SAN FRANCISCO PLANNING DEPARTMENT

Certificate of Appropriateness Case Report

HEARING DATE: FEBRUARY 18, 2015

Filing Date: October 8, 2014
Case No.: **2014.1422A**
Project Address: **900 NORTH POINT STREET: GHIRARDELLI SQUARE**
Historic Landmark: No. 30 – Ghirardelli Square
Zoning: C-2 (Community Business) District
40-X Height and Bulk District
Waterfront Special Use District, subarea #2
Block/Lot: 0452 / 002
Applicant: Elisa Skaggs
Page & Turnbull, Inc.
417 Montgomery, 8th floor
San Francisco, CA 94104
Staff Contact Pilar LaValley - (415) 575-9084
pilar.lavalley@sfgov.org
Reviewed By Tim Frye – (415) 575-6822
tim.frye@sfgov.org

TERRACE PLAZA DRAWINGS: LIFT, RAMP & STAIR

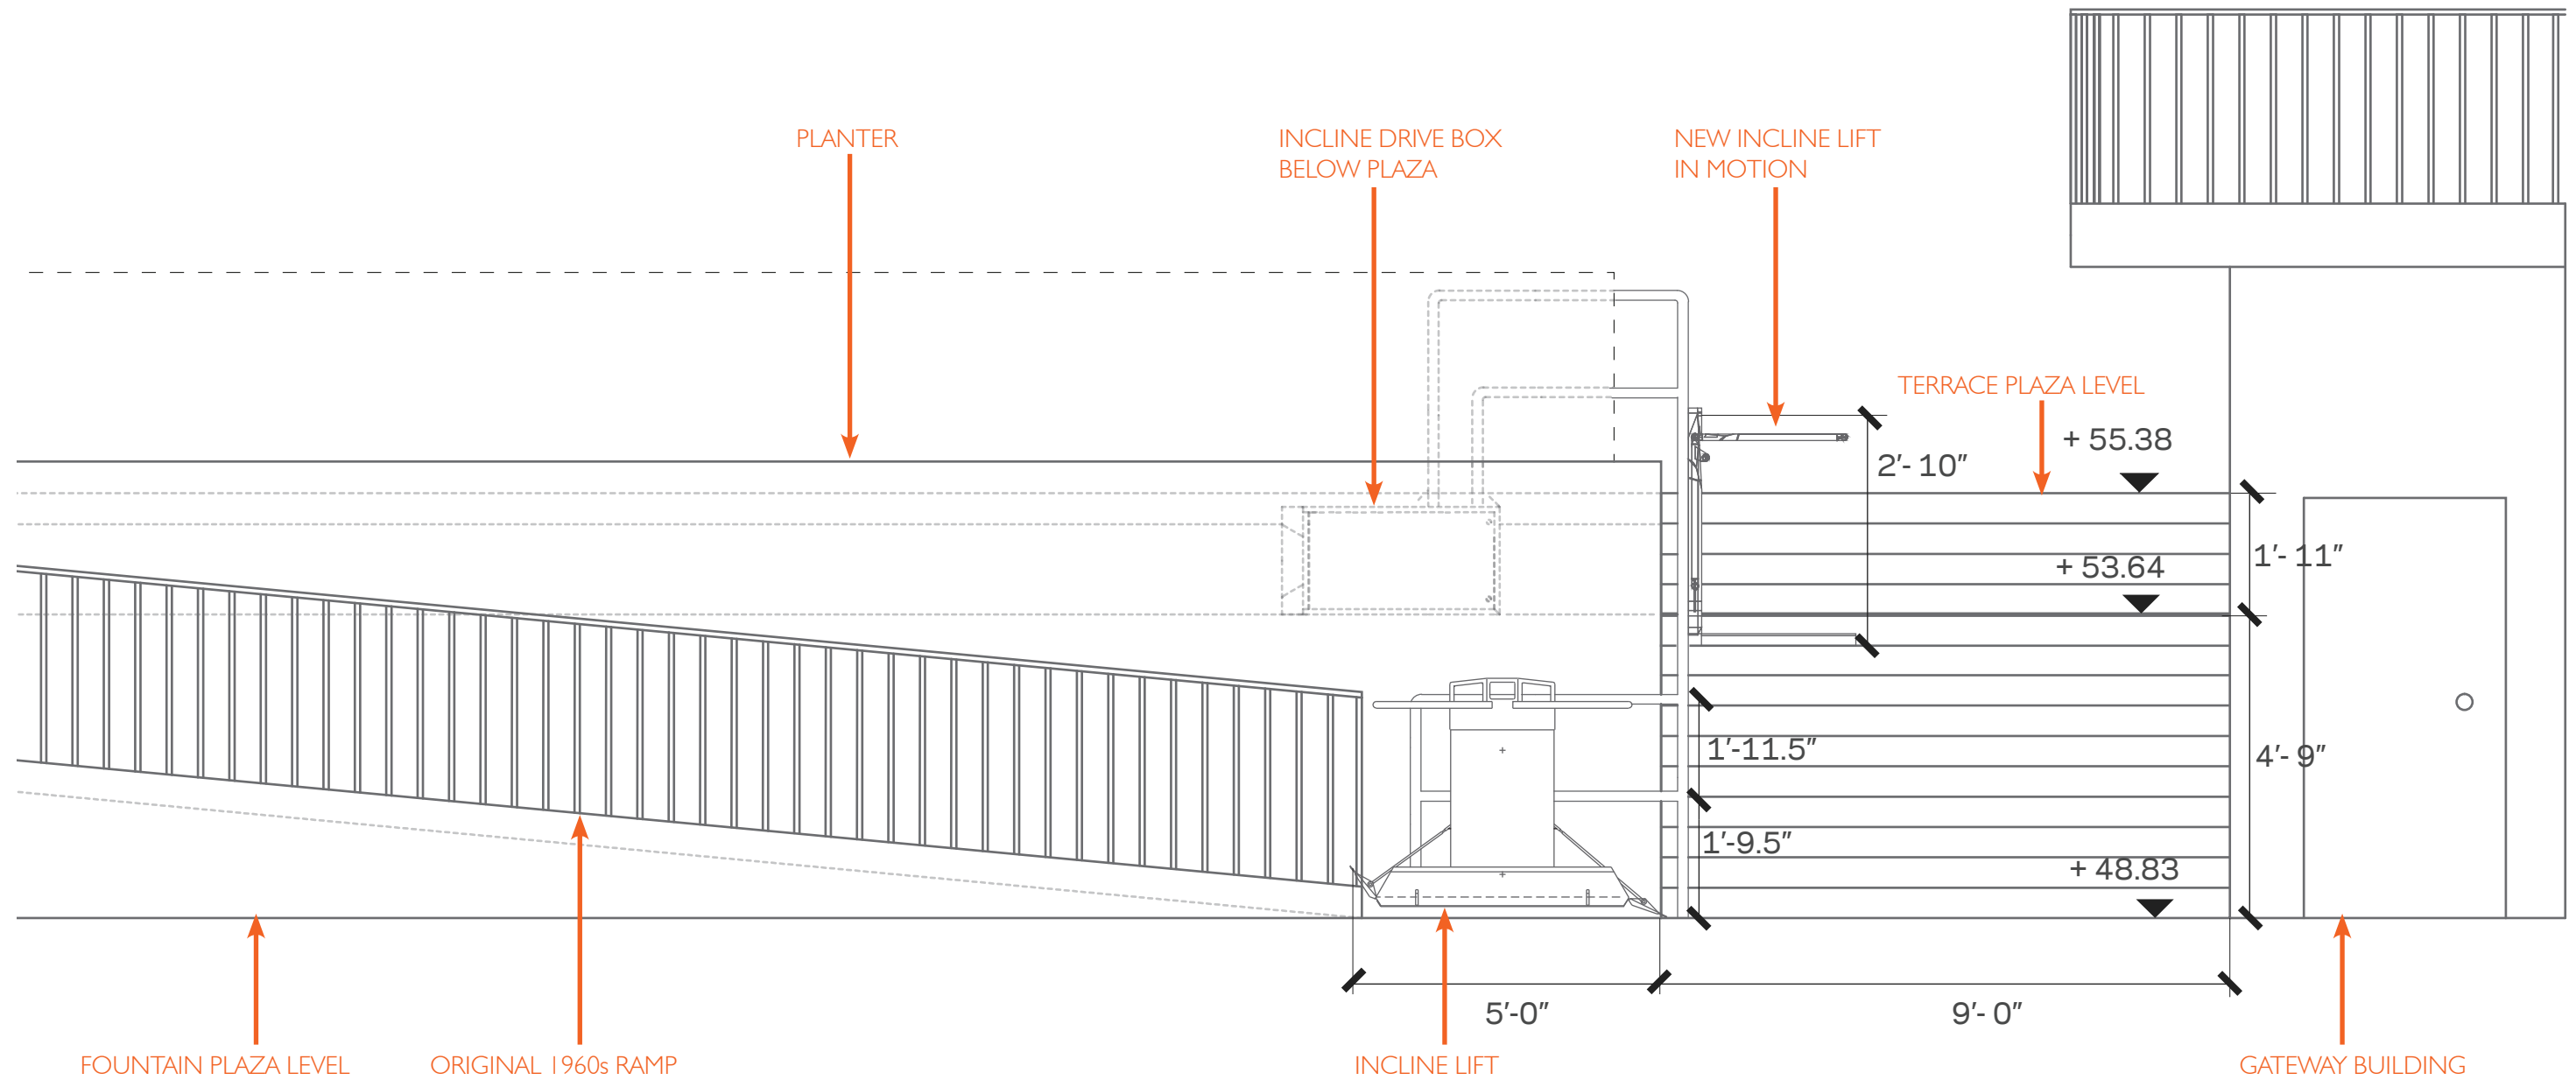
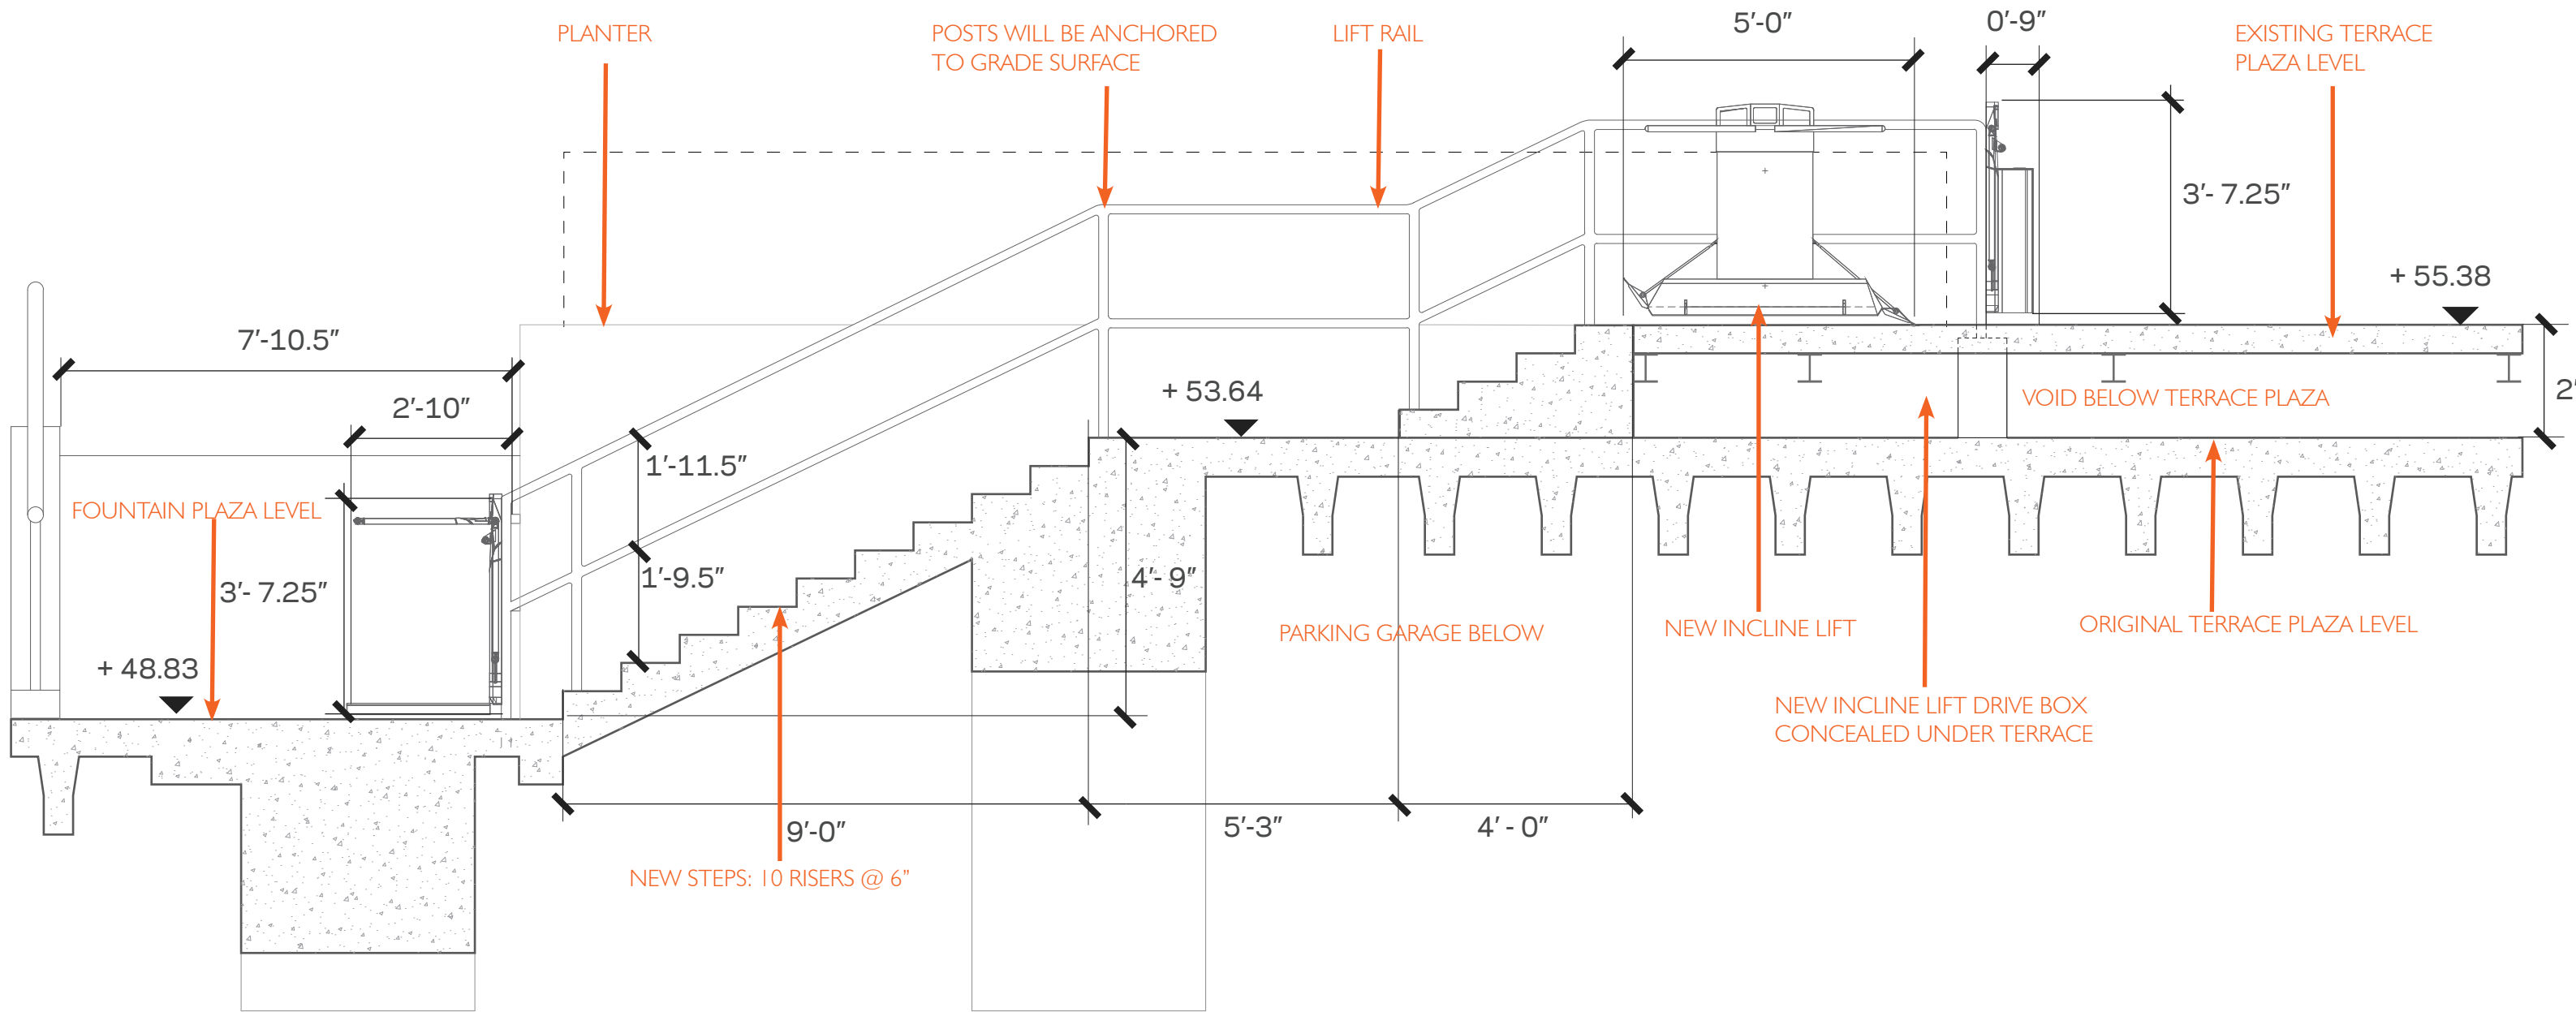
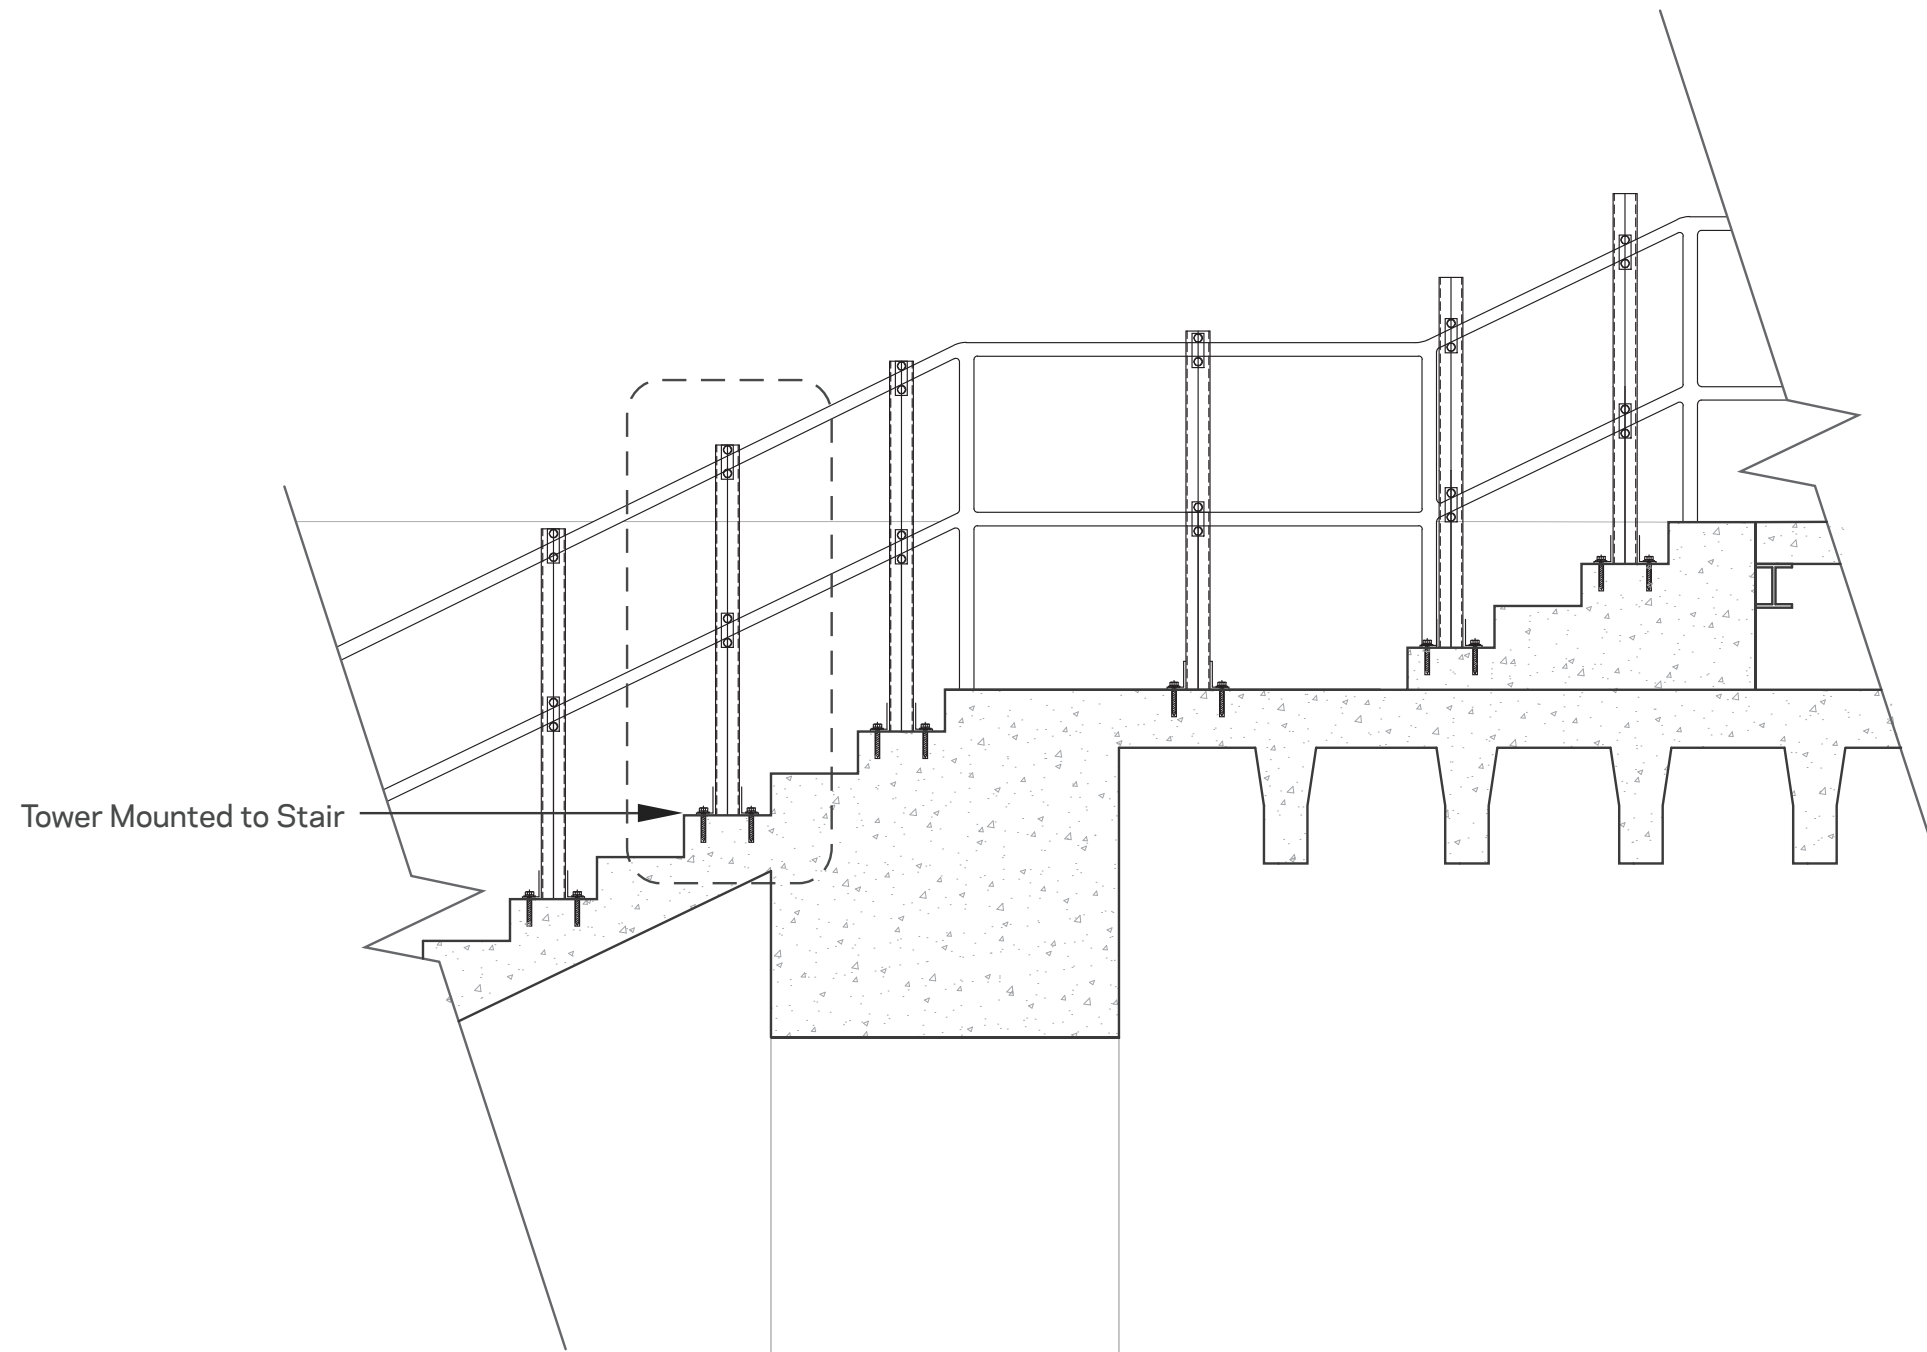
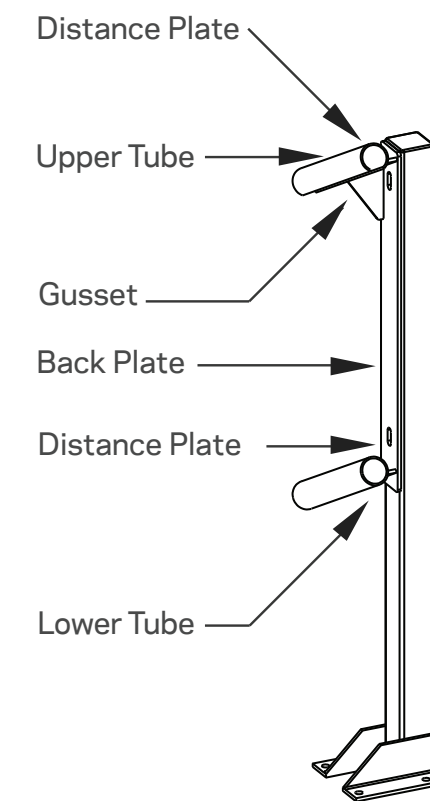
The proposed project will remove non-historic stairs and ramps within the Plaza and will install a new ramp and orthogonal stairs that are compatible with the original Halprin design. A new Incline Lift, providing Code-compliant accessibility to the site, will be installed at the western stair of the Plaza. The lift will be mounted on a simple metal railing anchored to grade surface. Machinery for the lift will be installed out of sight within the adjacent planter. As proposed, reconfiguration of stairs and ramps, and provision of incline lift, appears to be compatible with the character of the Landmark so long as new handrails and metal railing for the new lift have a dark finish to match existing railings found within the Plaza.

1. *Staff recommends that new handrails and metal railings have a dark finish to match existing railings found within the Plaza and Landmark property. Appropriate finish and color for handrails, metal railings, or similar features will also refer to the updated Design Guidelines for guidance.*
